## CORPORATION OF THE TOWNSHIP OF ESQUIMALT

**DEVELOPMENT PERMIT APPLICATION**  
**“REVIEW OF DESIGN REVISIONS FOR THE CORE AREA**  
**WASTEWATER TREATMENT PLANT AT MCLOUGHLIN POINT”**  
337 Victoria View Road  
Lot 1; Section 11; Plan EPP36468

## STAFF REPORT

**SUBJECT: DEVELOPMENT PERMIT APPLICATION**  
**“REVIEW OF DESIGN REVISIONS FOR THE CORE AREA**  
**WASTEWATER TREATMENT PLANT AT MCLOUGHLIN POINT”**  
**337 Victoria View Road**  
**Lot 1; Section 11; Plan EPP36468**

2 BUILDING ELEVATION - SOUTH  
A-6

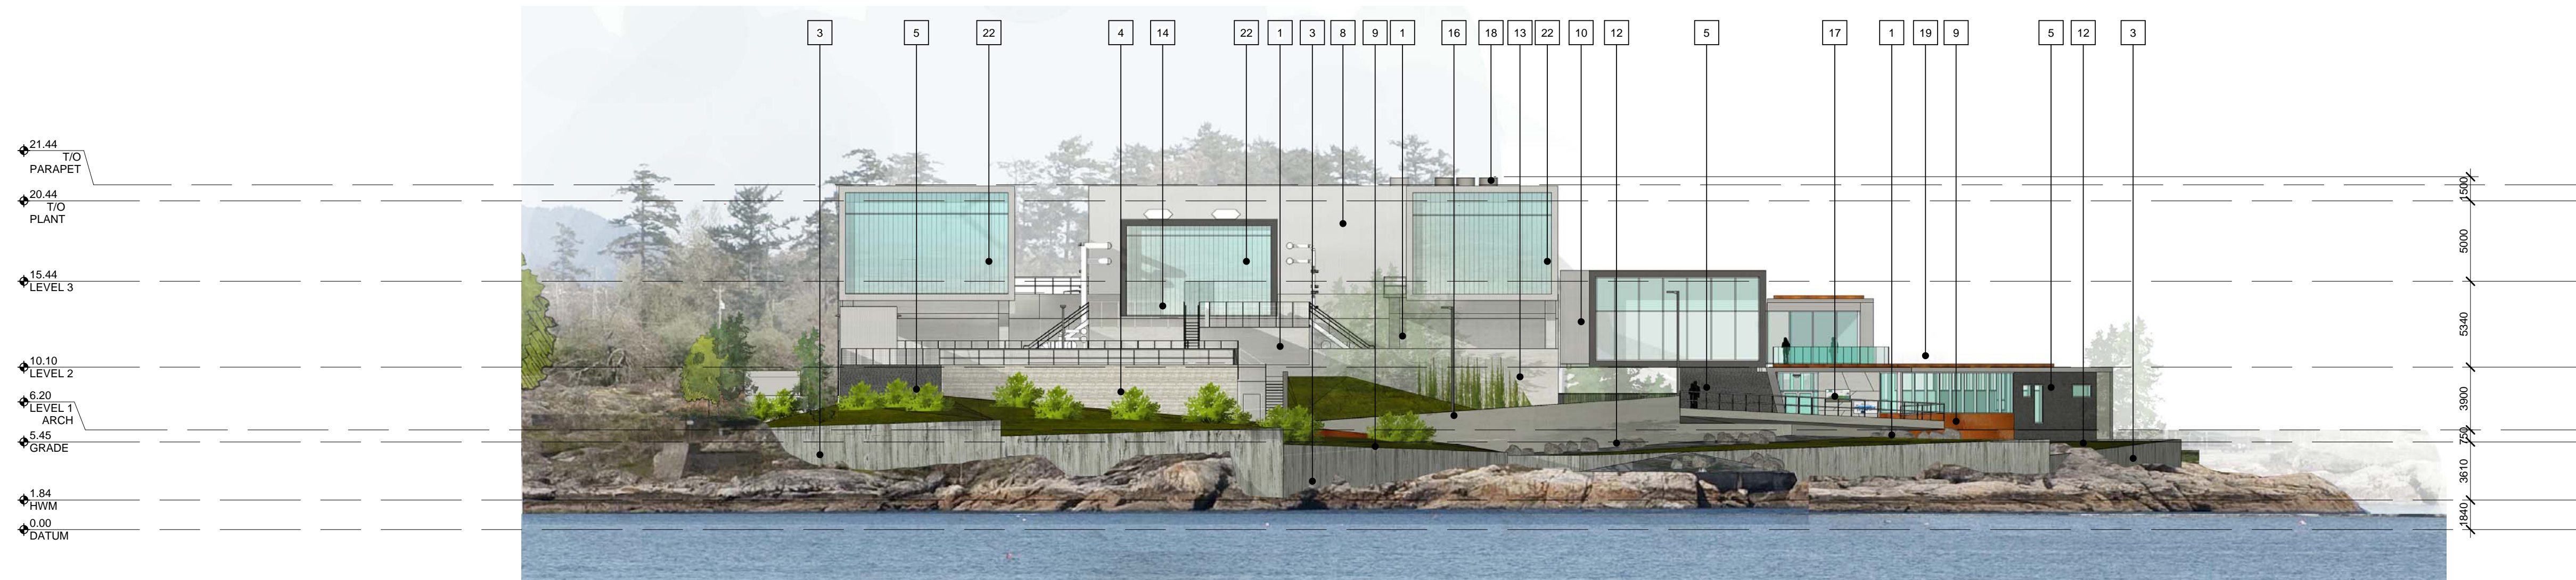
- 1) South elevation: The south end of the maintenance and operations portion of the building has been changed so that the building and fenestration has become rectilinear in order to match the rectilinear ends of the upper portions of the treatment plant portion of the building. Staff are concerned that, compared to the previous design, this is treatment may be less attractive. The Design Guidelines state that any development must, "Respect the site as a gateway location."
